**RATTLE FROM FRONT HEADRESTS**

**STANDARD SEAT**

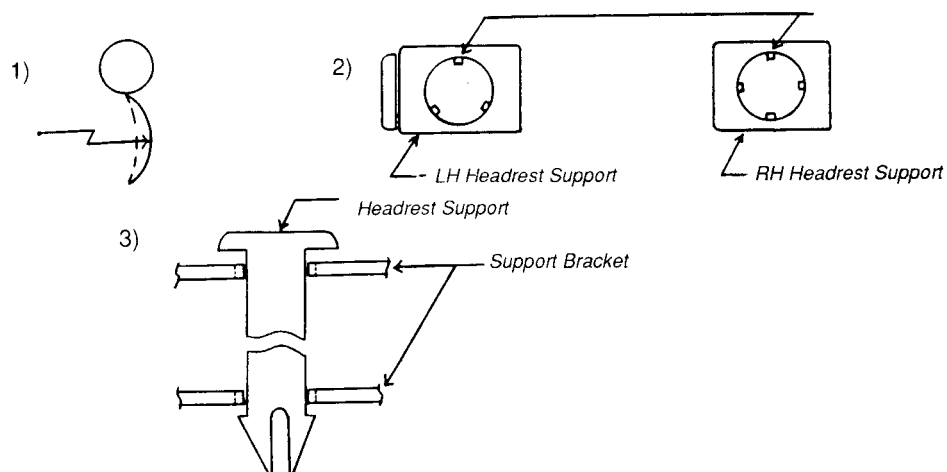
**CAUSE:** Rattle noise is caused by clearance between the headrest stay and the headrest support, or between the headrest support and the support bracket. See illustration below.

To reduce operating clearance between affected components, the following production changes have been made:

- 1) The curvature of the headrest stays have been increased starting with April, '90 production.
- 2) Ribs have been added to the headrest support from October, '90 production.
- 3) The diameter of the headrest support bracket has been reduced starting with November, '90 production.

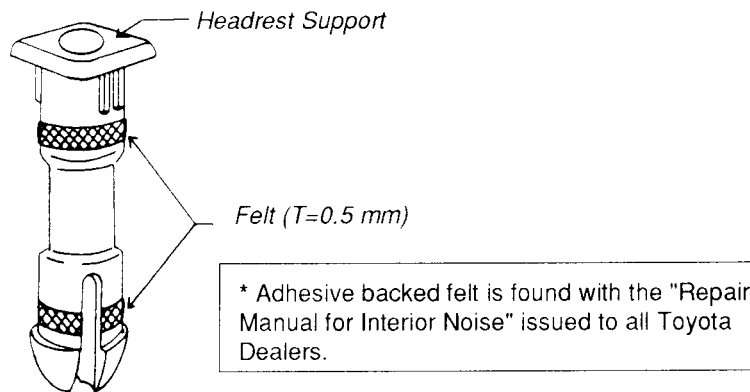
Attach adhesive backed felt strips\* (0.5 mm) to the headrest support bracket as shown below.

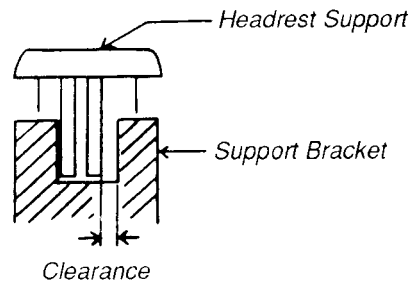
CAUSE: Rattle noise caused by clearance between headrest support and headrest support bracket. See illustration below.

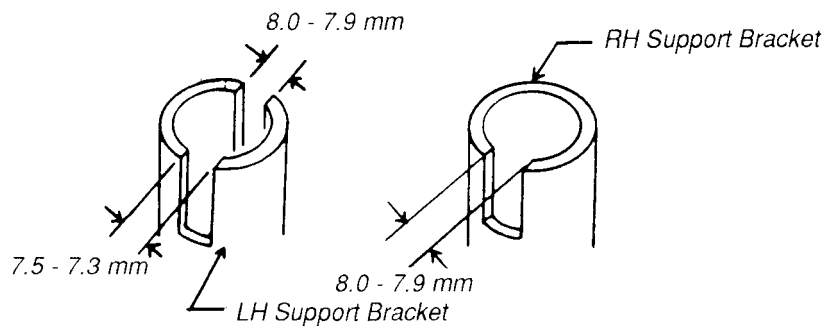
1) The groove of the headrest support bracket has been reduced starting with June, '90 production (see illustration).
